MISSISSIPPI POWER & LIGHT COMPANY

SUBJECT: Grand Gulf Nuclear Station
Units 1 and 2
Docket Nos. 50-416 and 50-417
File 0260/0862
Transmittal of Proposed FSAR
Changes and Responses to NRC
Questions
AECM-81/277

This information represents changes to the Grand Gulf Nuclear Station Final Safety Analysis Report (FSAR).

FIGURE 211.211-1

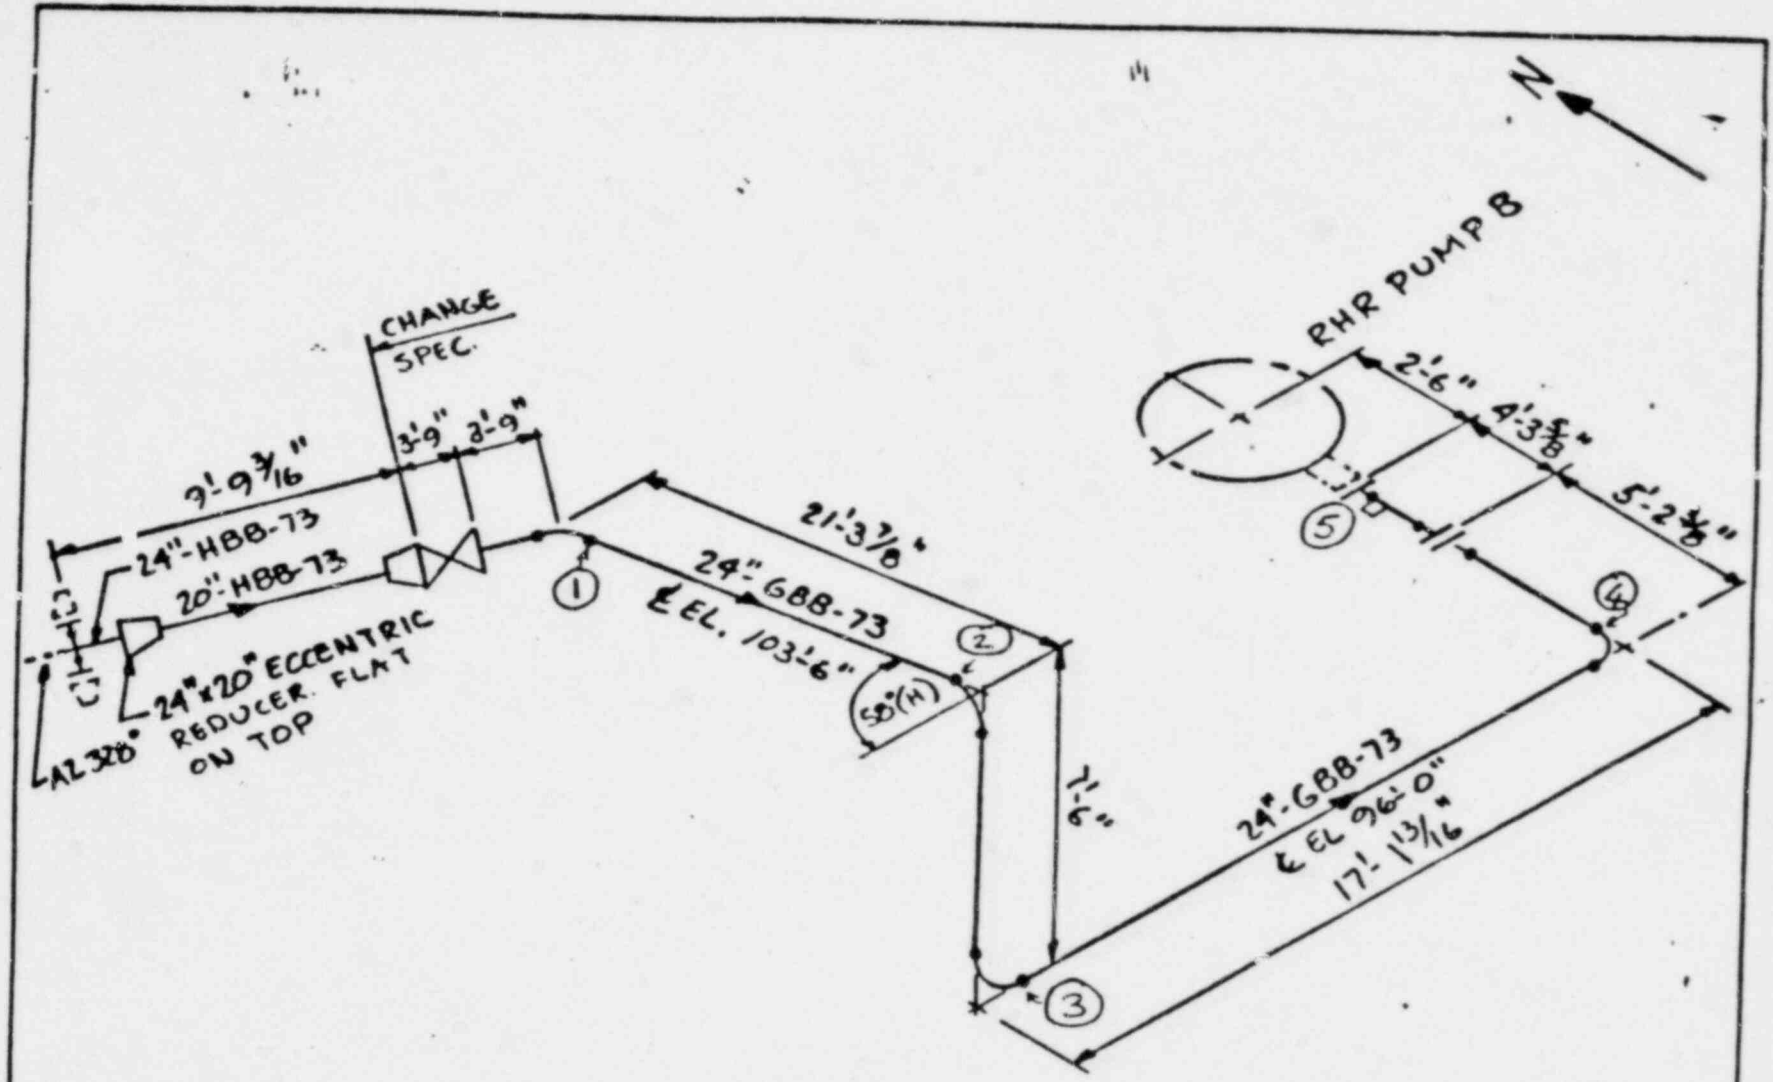
211.211 Calculations of NPSH available to ECCS pumps in BWRs are normally provided with reference to the pump suction. We are concerned that under certain post accident conditions the potential may exist for damage to ECCS pumps from cavitation because of local flashing in the system suction lines. The potential can result for example from local elevation changes in the piping runs. Calculations of NPSH available at the pump suction may erroneously assume liquid continuity up to the point of pump suction. We require therefore that the applicants provide calculations demonstrating that all points in all safety related suction piping, the NPSH available is adequate to preclude local flashing under the worst postulated conditions.

RHR "A" Pump

Reference Figure 211.211-1 (same as Figure 5.4-27 with the addition of data points) for suction line geometry.

$$\text{@ D.P. 1 } P_1 = 14.7 + 1.66 - 0.80 - 0.43 = 15.13 \text{ psia}$$

$$\text{@ D.P. 2 } P_2 = 14.7 + 1.66 - 0.80 - 0.19 - 0.43 = 14.94 \text{ psia}$$

$$\text{@ D.P. 3 } P_3 = 14.7 + 4.77 - 0.80 - 0.19 - 0.17 - 0.43 = 17.88 \text{ psia}$$

$$\text{@ D.P. 4 } P_4 = 14.7 + 4.77 - 0.80 - 0.19 - 0.17 - 0.49 - 0.43 = 17.39 \text{ psia}$$

$$\text{@ D.P. 5 } P_5 = 14.7 + 4.77 - 0.80 - 0.19 - 0.17 - 0.49 - 0.02 - 0.43 = 17.36 \text{ psia}$$

Summary: The pressure at all points along the suction piping exceeds the vapor pressure (14.7 psia) at 212°F.

SETTLEMENT VS TIME
 UNIT 1
 TURBINE BUILDING
 FIGURE 2.5-75a

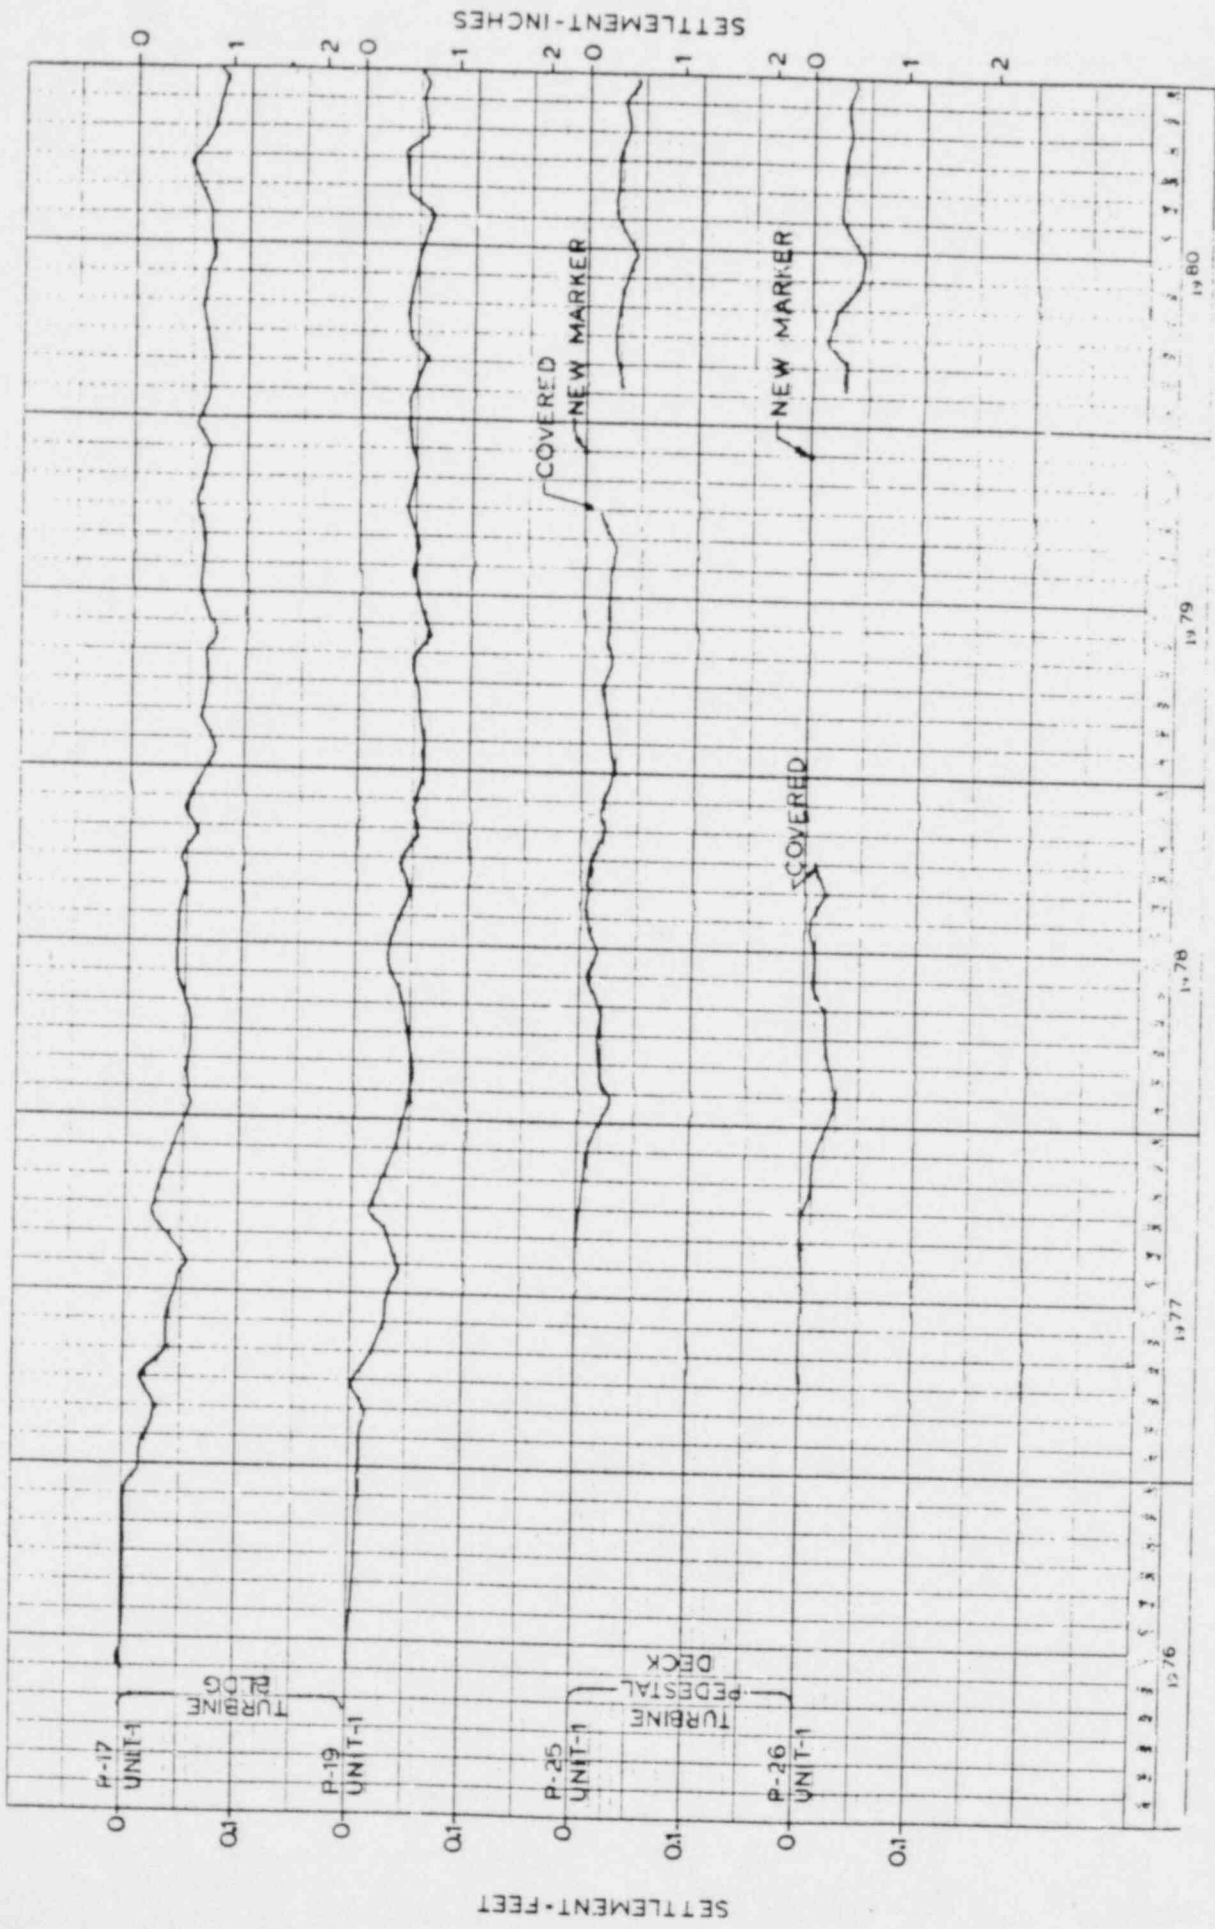
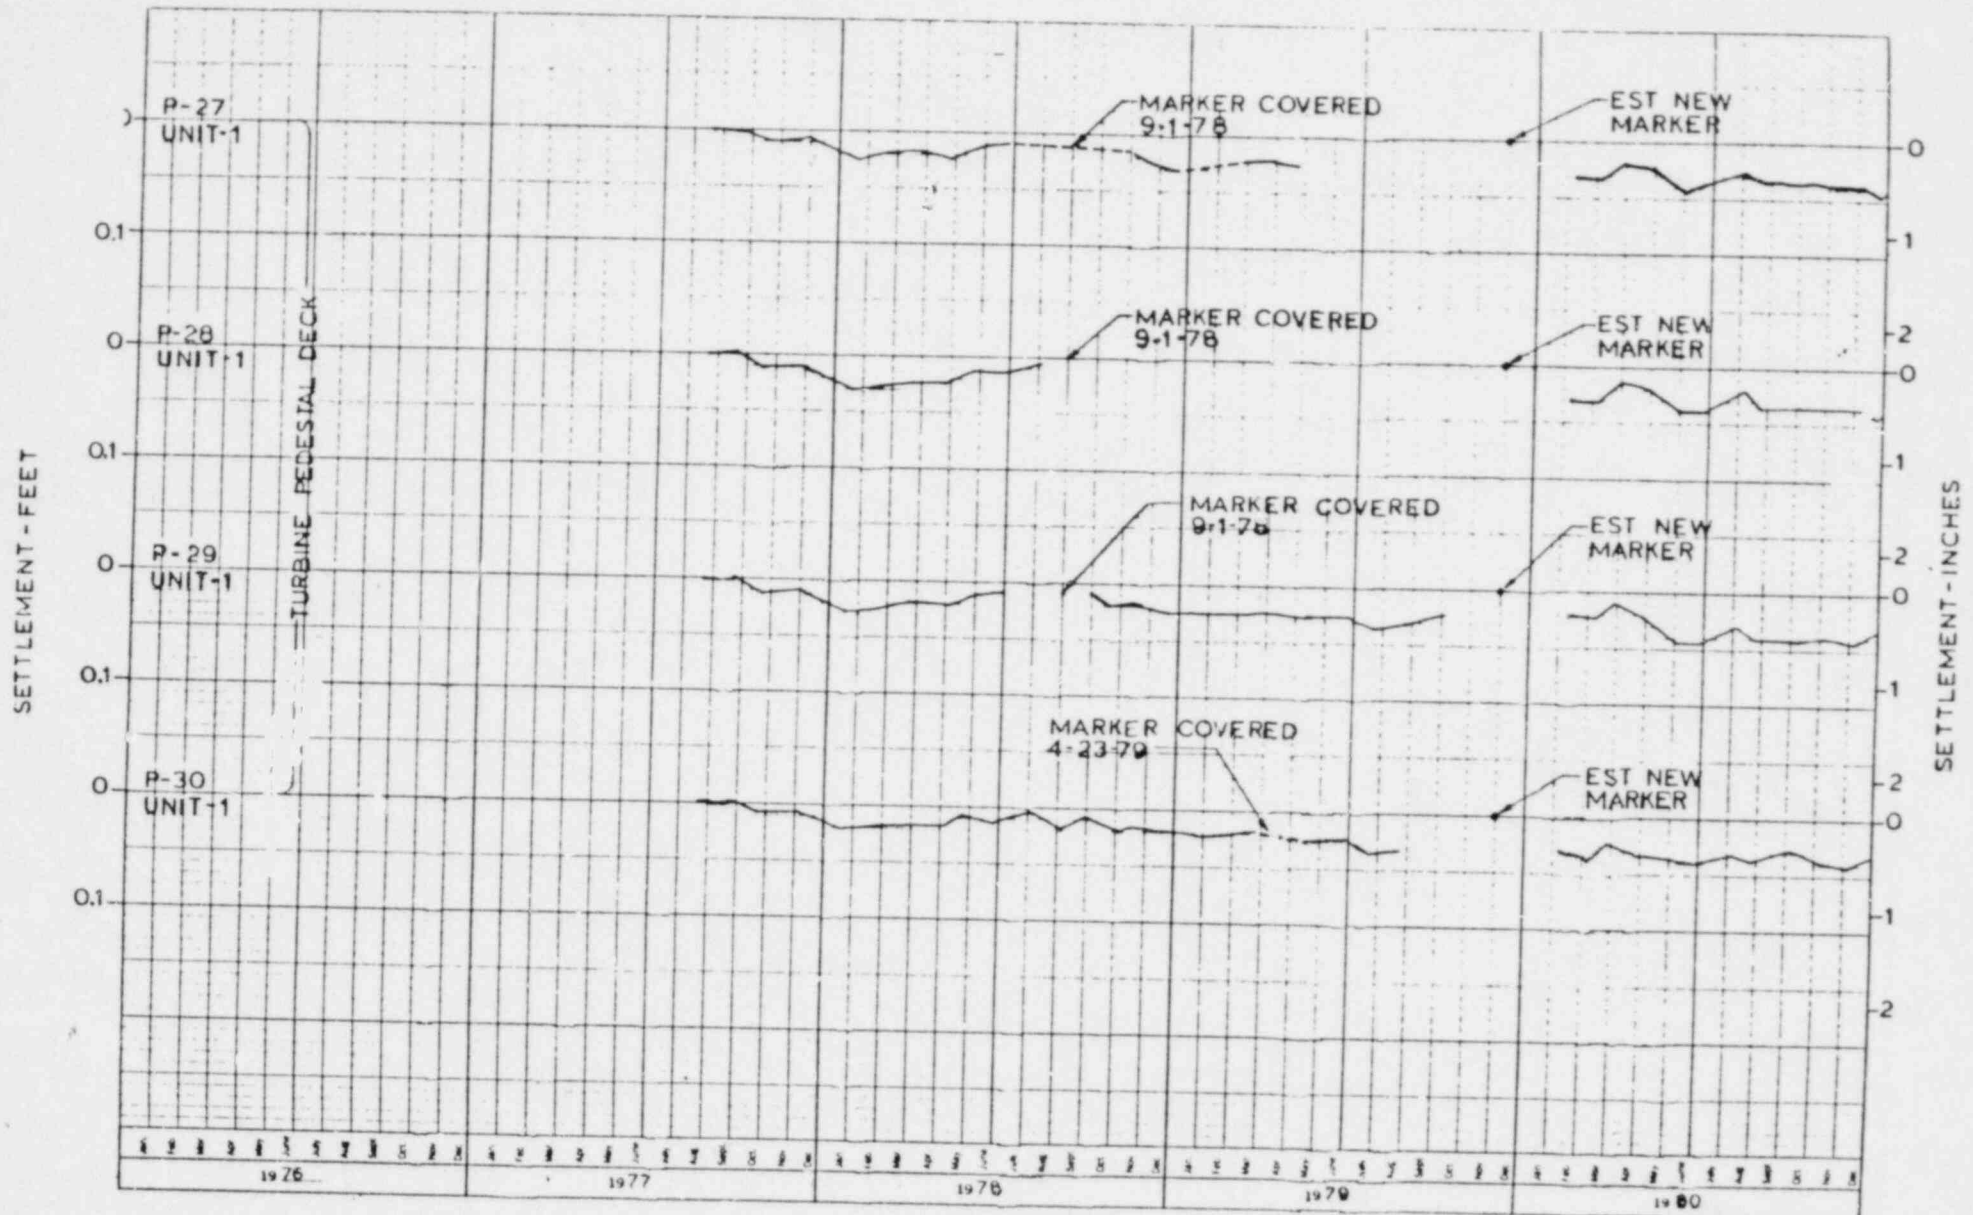
362.7
(2.5.4.13.1) Your response to NRC Question 362.5 (page Q&R 2.5-14, Amendment 30) is not complete. Indicate what measured value of differential settlement would cause code allowable stresses to be exceeded for individual buildings and buried piping and require notification of NRC. Provide a table of these values and the limiting stress criteria. Update the plots which show settlement recorded to date versus time; this is particularly important since construction of Unit 2 was still underway when your response to Question 362.5 was being developed.

The response to this question is given in revised subsection 2.5.4.13.1, revised Table 2.5-10 and revised Figures 2.5-75a through 2.5-75h.

The settlement markers will be read at one-month intervals until construction is complete and all pools are filled with water, at which time the results of the settlement monitoring program will be evaluated and long-term monitoring of the structures will be assessed. Total settlement will not be a Geotechnical concern until the following measured values are observed:

Turbine building	3"
Radwaste building	3"
Control building	3"
Containment building	3.5"
Auxiliary building	3.5"
Diesel generator building	3"
